Status	Revision	Date	Description
S2	C02	15/11/2024	Construction issue
S2	C01	14/06/2024	Construction issue

Project
SUNLIGHT HOUSE
Little Quay St,
Manchester M3 3HP

Drawing title
**DEMOLITION ARRANGEMENT
PLAN
LEVEL 01**

Drawing number
SLH-ANO-P0-01-DR-A-03101

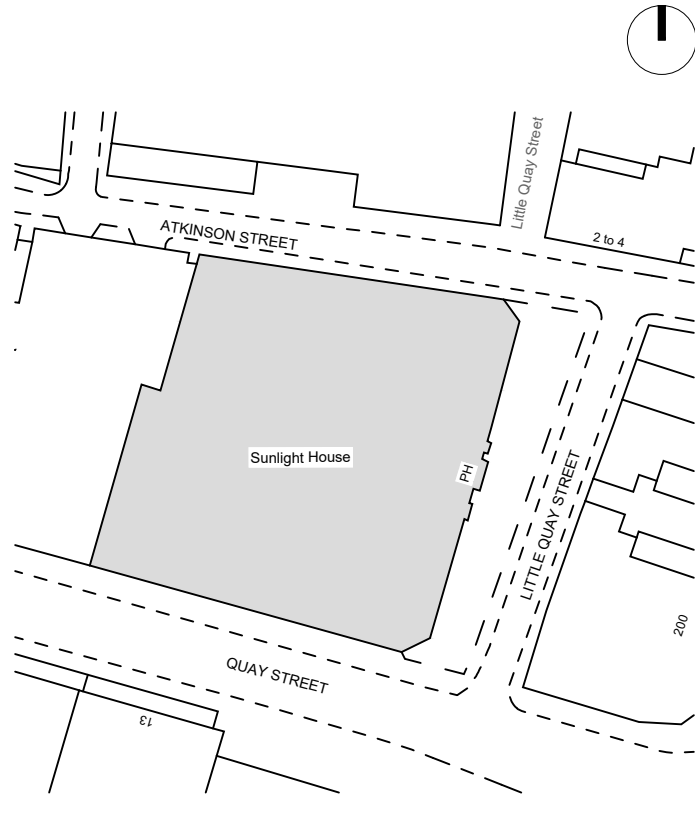
C02 - NOTE INCLUDED

HIGH-LEVEL OPENINGS FOR THE VENT GRILLES TO BE FORMED ALONG THE CORRIDOR WALLS. REFER TO THE PROPOSED DESIGN FOR THE LOCATION AND OPENING SIZES.

INCREASE EXISTING DOOR OPENING. AWAITING CONFIRMATION OF STANDARD DOOR DESIGNS FROM THE DOOR SUB-CONTRACTOR. HEIGHT TO BE INCREASED TO 2400MM. TO BE COORDINATED WITH THE STRUCTURAL ENGINEER.

C02 - NOTE INCLUDED

C02 - UNIT ADDED TO SCOPE

C02 - EXISTING WALL ADDED TO SCOPE OF DEMOLITION

C02 - NOTE INCLUDED

PARTIAL REMOVAL OF ONE WALL AND TO FORM AN OPENING. REFER TO PROPOSED DESIGN FOR INFORMATION.

DEMOLITION OF THIS WALL SUBJECT TO PLANNING AND LBC APPROVAL. ENSURE ALL PLANNING CONDITIONS AND APPROVALS ARE OBTAINED PRIOR TO ANY WORKS.

C02 - NOTE INCLUDED

REMOVAL OF ONE WINDOW AND LOW LEVEL WALL TO FORM A NEW DOOR OPENING. REFER TO DOOR PACKAGE [36] FOR PROPOSED DESIGN.

UNIT ADDED TO SCOPE AT THE LATER STAGE. IT WILL REQUIRE SOFT STRIP WORKS TO ALL NON ORIGINAL FABRIC INCLUDING REMOVAL OF FIT OUT, FLOORING, LIGHTING AND MEP.
